UNITED STATES ARMY AVIATION BOARD
Fort Rucker, Alabama

REPORT OF TEST

PROJECT NO. AVN 1162

EVALUATION OF RYANAV IV DOPPLER NAVIGATION
SYSTEM

Figure 1.
RYANAV IV
receiver/
transmitter

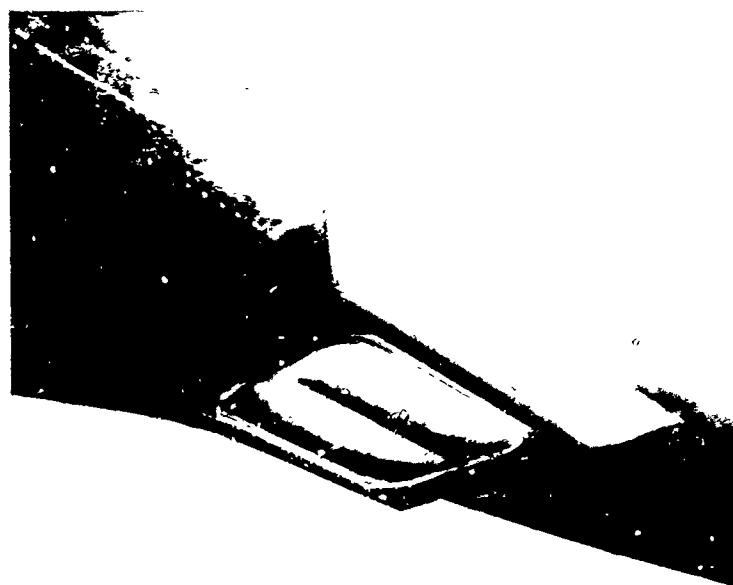
a. Installation Requirements. The RYANAV IV antenna could not be flush-mounted in any standard US Army aircraft (figures 1 and 2). The antenna installation in the R4D was a major modification to the aircraft requiring design of the antenna mounting and Navy airworthiness certification. A cut-out of 26 inches x 30 inches was required in the underside of the R4D fuselage and the depth of the antenna required that it extend below the fuselage approximately three inches. The receiver-transmitter and hi-voltage power supply of the RYANAV IV were installed in the right underside of the R4D fuselage beneath the cargo floor. All other components of the system were installed on the test bench in the airplane and required only normal shock mounting or instrument panel installation. Details of the installation are contained in appendix C.

<u>DEFICIENCY</u>	<u>SUGGESTED COR- RECTIVE ACTION</u>	<u>REMARKS</u>
1. Antenna is too large for flush-mount installation in Army aircraft.	Redesign antenna to a smaller size for installation in Army aircraft.	Informal information indicates this has already been accomplished by the manufacturer.

Figure 3. AFC plotting board

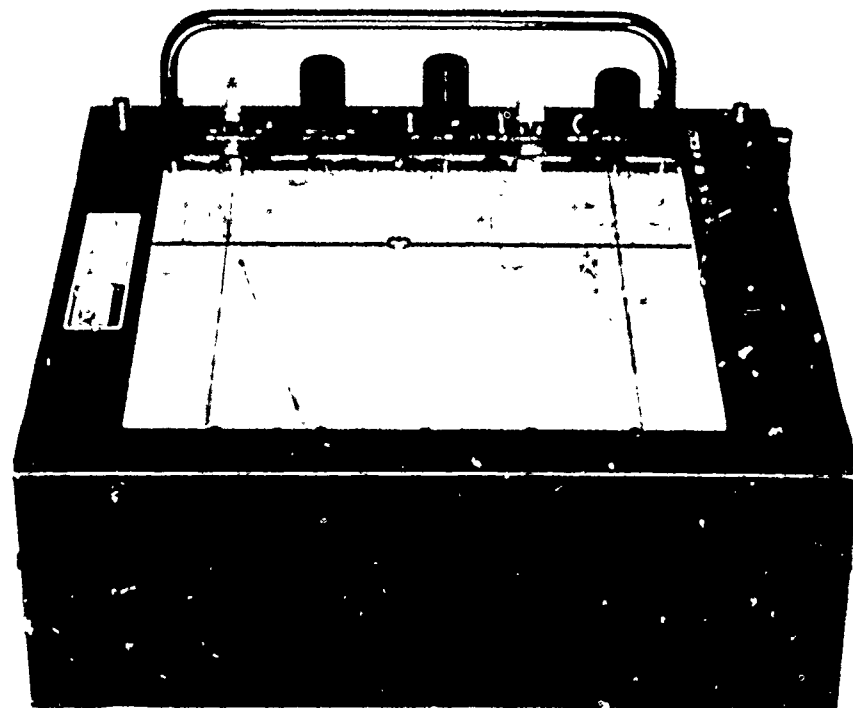
(2) The plotting board (see figure 3) had limited application in this configuration. Templates used in the plotting board covered 40-nautical-mile square areas for charts of 1/500,000 and 80-nautical-mile square for charts of 1/1,000,000. At an average airspeed of 140 knots on a generally straight-line mission, it was necessary to change templates every 17 minutes for the 1/500,000 charts and every 34 minutes for the 1/1,000,000 charts.

Figure 4. Hover indicator

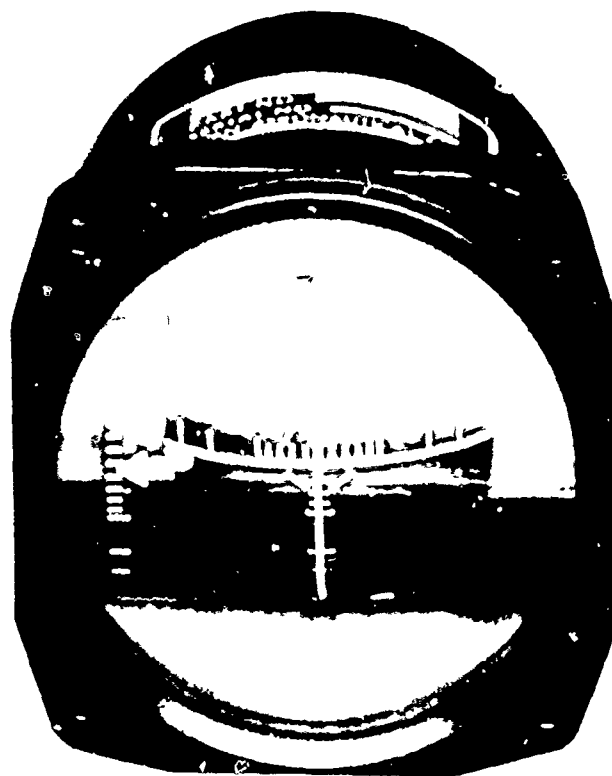
(3) For helicopter operations, where missions would be short and a return to base would complete the mission, the plotting board could be of great value; however, it will be necessary to determine this in subsequent evaluations of self-contained navigators. If the RYANAV IV were to be utilized in helicopters, a hover indicator (3 1/4 inches x 3-inch diameter and weighing 12 ounces), which is available, could be incorporated (see figure 4).

Figure 5.
Groundspeed/
drift-angle,
windspeed/wind-
direction indicator

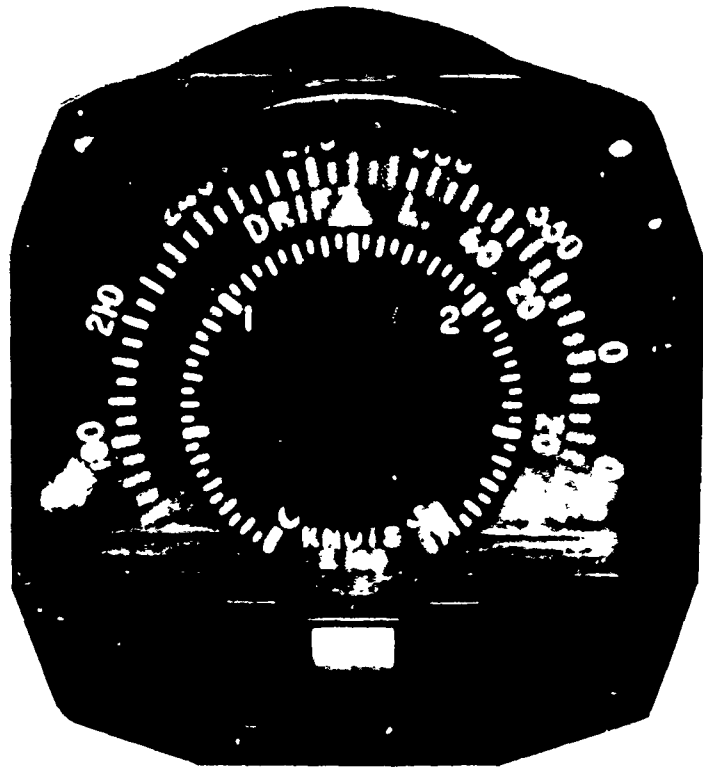
(1) The groundspeed/drift-angle, windspeed/wind-direction indicator (figure 5) was difficult to read and differed from normal instrument presentation in that:

(a) One index served for both wind direction and drift angle, but used two sets of numbers for read-out. The wind direction was shown on a compass card with the numbers on the outside of the card; the drift angle was shown as "Left" or "Right" with the numbers nearer the center of the instruments.

(b) When switching from groundspeed/drift-angle to windspeed/wind-direction, the "knots x 100" pointer oscillated wildly for 5 to 10 seconds before stabilizing.

(c) The outside compass card of the instrument accepted and displayed instantaneous Doppler information without

damping, thus jerking and jumping at intervals of from one to five seconds in increments of five to fifteen degrees. The groundspeed and windspeed pointer varied constantly but in much smoother and smaller increments.

2. Presentation of the groundspeed/drift-angle, windspeed/wind-direction indicator is too complicated and information was displayed erratically and with oscillations.	Redesign indicator with damping incorporated taking into consideration engineering factors with regard to readability and simplicity of the instrument face.

Figure 7. Indicator shown in figure 6 as changed during test

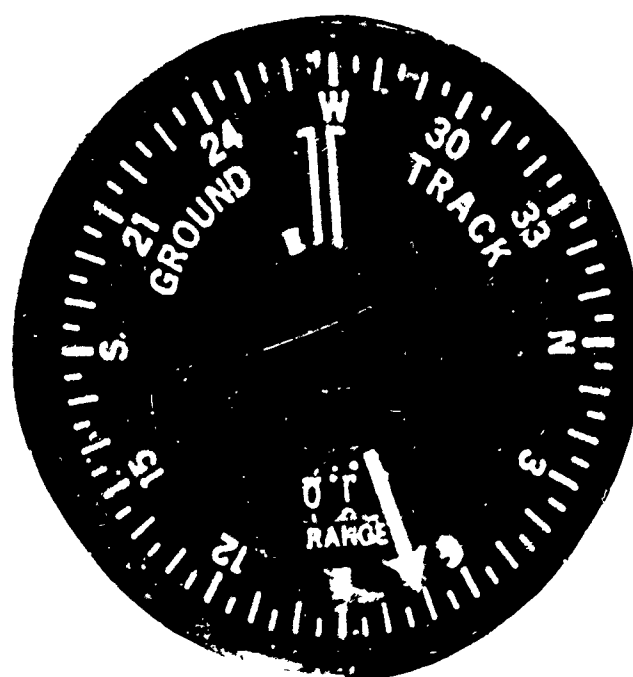
(2) At the beginning of the test, the ground-track, bearing-to, and range indicator displayed ground track on a compass card that had the heading numbers on the outside of the card and the degree increments on the inside (figure 6). This was later reversed (figure 7), enabling easier interpretation. The numbers on the digital range read-out were too small for normal operation and were hidden by the center of the instrument when viewed at an angle from above.

3. Bearing-to, ground-track, and range indicator has numbers in the digital range read-out which are too small for normal operation and are hidden by the center of the instrument when viewed at an angle from above.	Redesign the digital readout so that the digits are large enough for normal operation, and relocate the read-out so that it is readily readable from all normal observing angles.	The manufacturer has partially corrected this by enlarging the digits. However, the digital read-out has not been relocated.

Figure 9. Computer indicator group

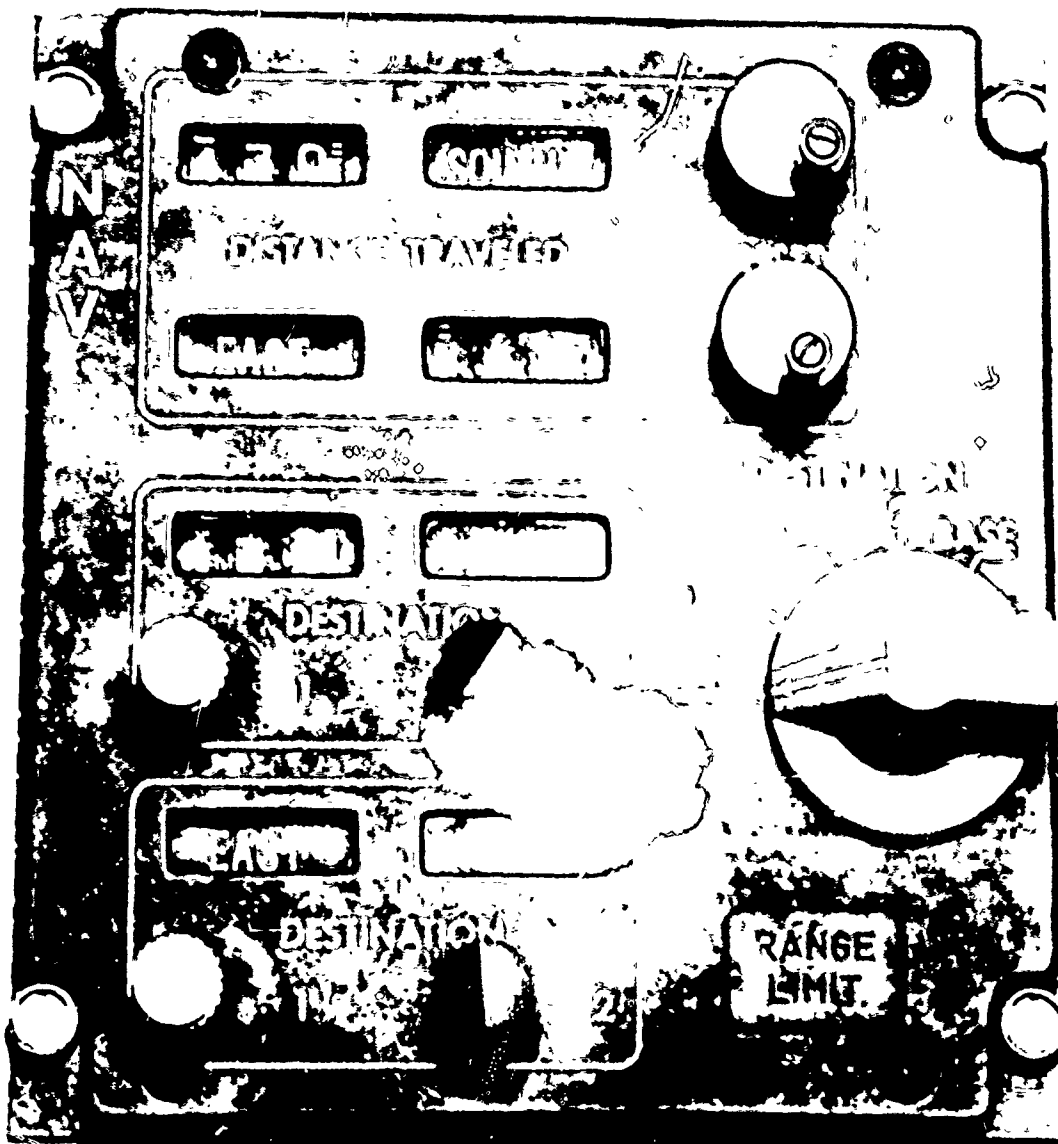
(2) The computer indicator (figure 9) was very difficult to operate in that the controls necessary to set destinations were overly sensitive, and it was extremely difficult to set the desired destination.

<u>DEFICIENCY</u>	<u>SUGGESTED COR- RECTIVE ACTION</u>	<u>REMARKS</u>
4. The computer indicator was very difficult to operate in that the controls necessary to set destinations were overly sensitive.	Damp and gear the controls so that they are less sensitive and are not jerky.
